6-2– 12

602.3

Proposed Change as Submitted

604.4, Figure 604.4

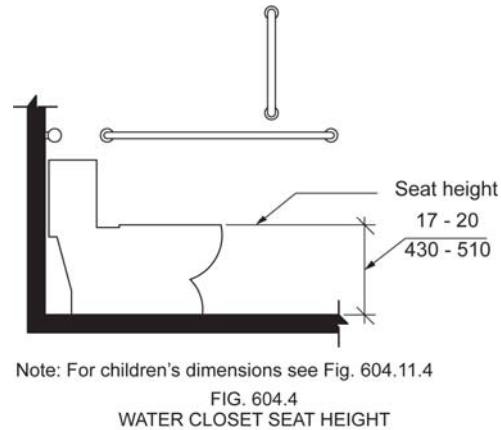
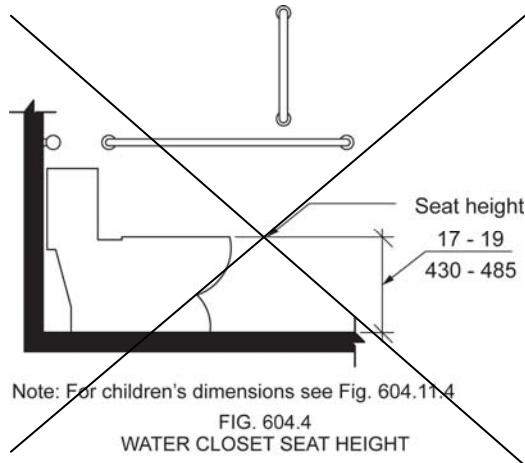
NOTE: This change necessitates a change to Fig. 604.4 to ensure consistency. Thus, the proposed revised figure has been attached, along with the existing figure for comparison purposes.

Comment: The research results clearly shows that a higher range would be beneficial for wheeled mobility users but allowing fixed heights as high as 25 in. could cause difficulty for people who need low seat heights, as the committee noted in defeating the original proposal. I didn't think about an amendment when we voted on the proposal but only exception #1 was changed it would allow a range from 11-25 in. for adjustable water closets. This would mean that, as adjustable products come on the US market, they would provide a great alternative to the fixed seat height that would be too low for many people yet not disadvantage people of short stature or children with disabilities. At the July meeting, I will offer this proposal.

Approval with Modifications based on Comment

Committee Reason: The committee was asked to consider just approving the proposed exception. There remain concerns regarding the structural stability and durability of the devices. There is also concerns regarding ability of keeping the devices sanitary. The proponent encouraged the approval of generic language which would allow the market to address the concept and make sure that any device could adjust to provide a height within the standard's range of accessibility.

6-20– 12**Table 604.9.3.1, Figure 604.9.3.1*****Proposed Change as Submitted***

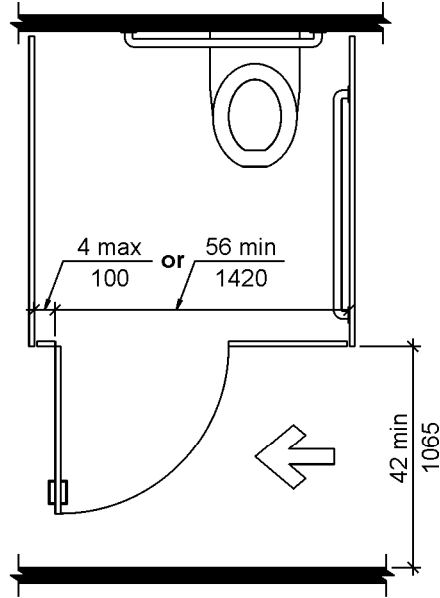
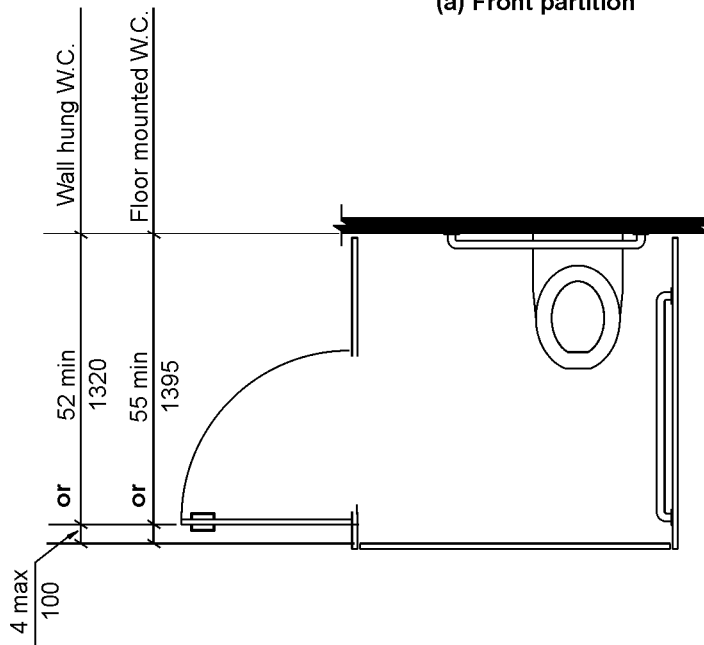
Change the called dimension for door opening location to read: 4 inches (100 mm) minimum to 6 inches (150mm) maximum.

Committee Reason: The change would make the table more difficult to understand and therefore use. Changing from 4 inches maximum to a 4 inch minimum/6 inch maximum range would eliminate currently acceptable installations which are less than 4 inches.

Comment: Change to 4 inch minimum to 6 inch maximum space for stile would be more practical to install and comply. Tables and figures with 4 – 6 inch range would be consistent with other tables and figures that present ranges (Example: Table of Dimensions at Water Closets Serving Children Ages 3 through 12). Since 4 inch wide stiles are industry standard, acceptable installations less than 4 inches are in the minority. Additionally, the 4 inch or less wide stile is not the most ideal from a strength standpoint support from which to hinge a 32 inch plus wide outswing door.

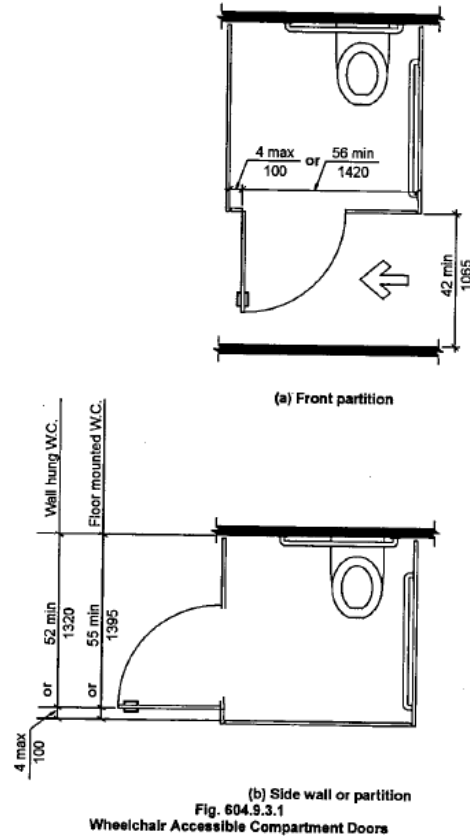
Change the called dimension for door opening location to read: 4 inches (100mm) minimum to 6 inches (150mm) maximum.

1. Change to a single 6 inch maximum dimension is easily understood. This revision to the original proposal overcomes one of Committee' two reasons for disapproving the original proposal.

Revise Figure 604.9.3.1 to match table. Change the called dimension for door opening location to read 5 inches (127 mm) maximum.

FIG. 604.9.5
WHEELCHAIR ACCESSIBLE COMPARTMENT TOE CLEARANCE

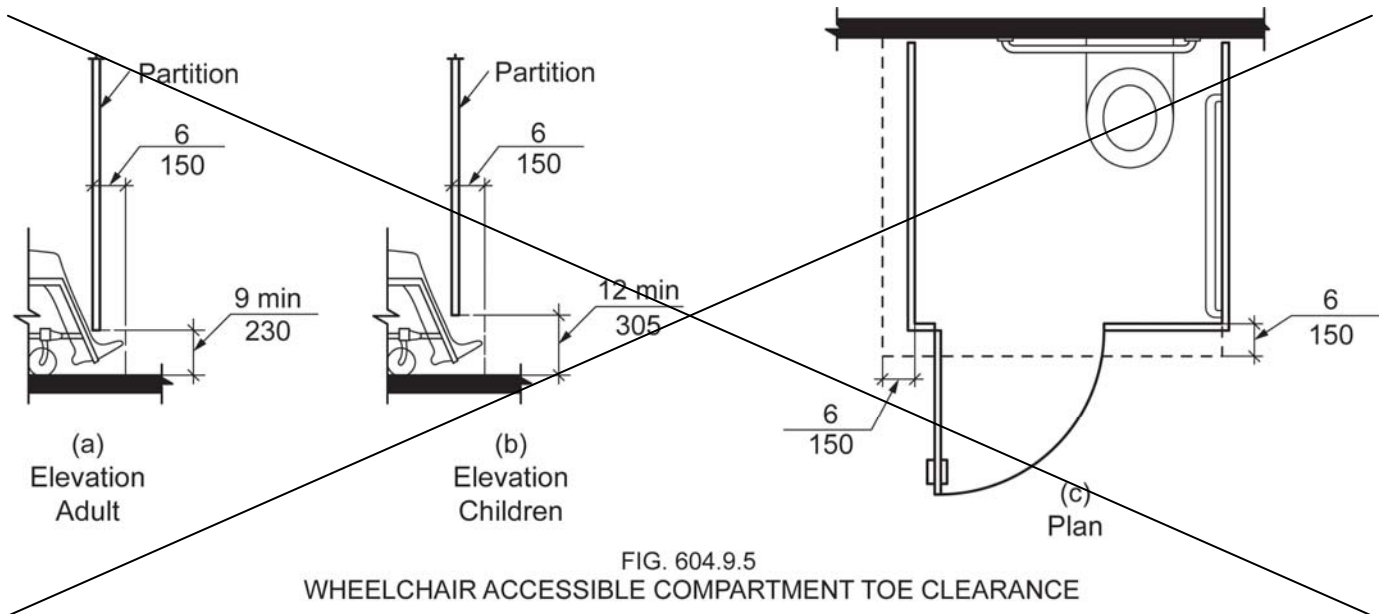
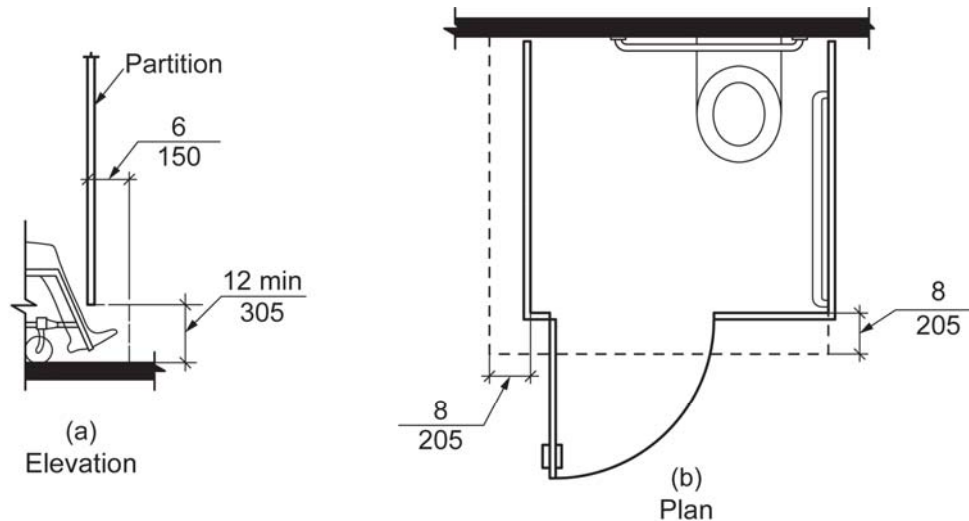
NOTE: This change necessitates a change to Fig. 604.9.5 to ensure consistency. Thus, the proposed revised figure has been attached, along with the existing figure for comparison purposes.

In addition, it has proved to be necessary to keep the children's provisions in a separate section for ease of use of the standard. Even if this proposal goes through to change the size, the format for separate sections should be maintained.

Comment: The work of the study group isn't finalized and the research that formed the basis for this change has not been validated.

Committee Reason: The committee agreed with comment 6.22-1 that the existing format of the standard with separate sections for children's facilities and other facilities was easier to use. The intent of the original change was maintained and formatted into the existing organization.

608.2.1.2, Figure 608.2.1

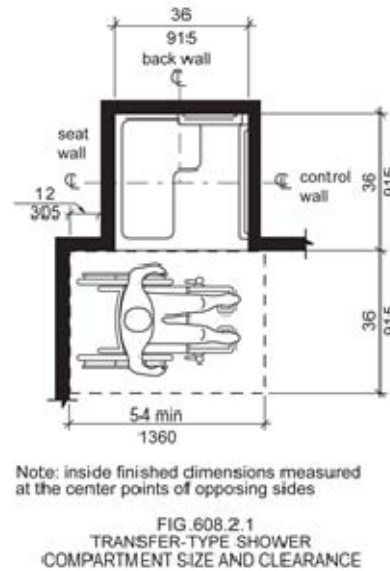
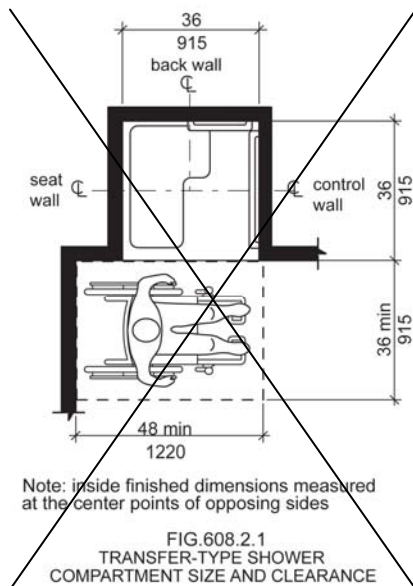
Note: The Editorial task group should make sure that the figure clearly shows the measurement of the 12 inches be from the inside of the wall of the shower.

Comment: No technical substantiation was provided in the report to support the added requirement of 12 inches beyond the seat wall, since the report did not include any anthropometric study on transferring to and from a shower seat. The requirement has been in the standard for several cycles and should not be changed without adequate justification. Also see negative comment 3-13-12 regarding the CFS increase.

The change in the clearance combined with the 12” offset from the seat wall will result with 4” past the control wall. The result is the transfer shower no longer permitted to be located in the corner, but must instead be at least 4 inches from the wall.

Committee Reason: With the increase in the clear floor space approved in Proposal 3-13-12, the clearance needs to be revised to accommodate the larger space. The result of the modification is to change the current 48 inches to 52 inches. The added 4 inches will occur 'at the toes' of the user. There was considerable debate whether the added space should be at the toes or at the back of the wheelchair or balanced. Information provided by the proponent is the location of the shoulders adjacent to the seat is the most important for this transfer.

608.4.3, Figure 608.4.3

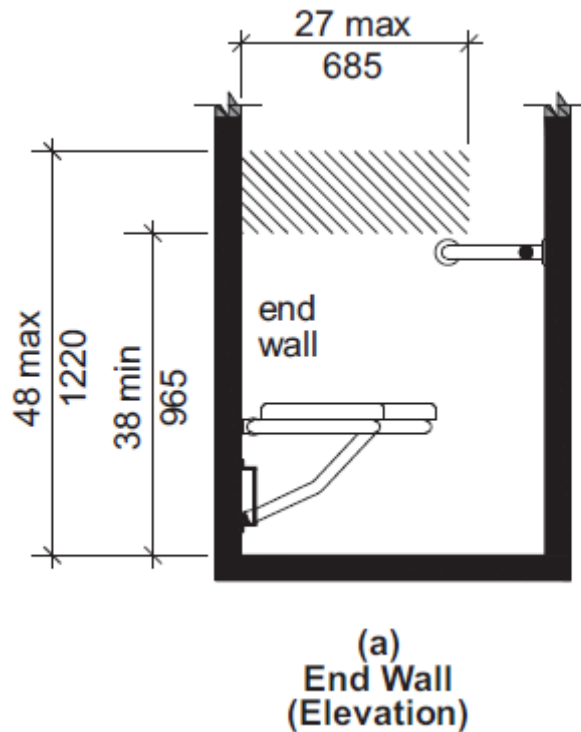
Modify figure to show a 16 inch minimum requirement to go along with the existing 27 inch maximum dimension to create a range for controls to be located and measured from seat wall.

In the 2009 edition of the standard, Section 608.4.2 dealing with a standard roll-in shower was modified to create this 16 to 27 inch range for the controls. The purpose behind that change was to ensure the controls were not located over the seat and did not require a person using the seat to reach beside or behind them to operate the controls. It seems appropriate to make the alternate roll-in shower requirement consistent and also keep the controls forward where they will be more usable.
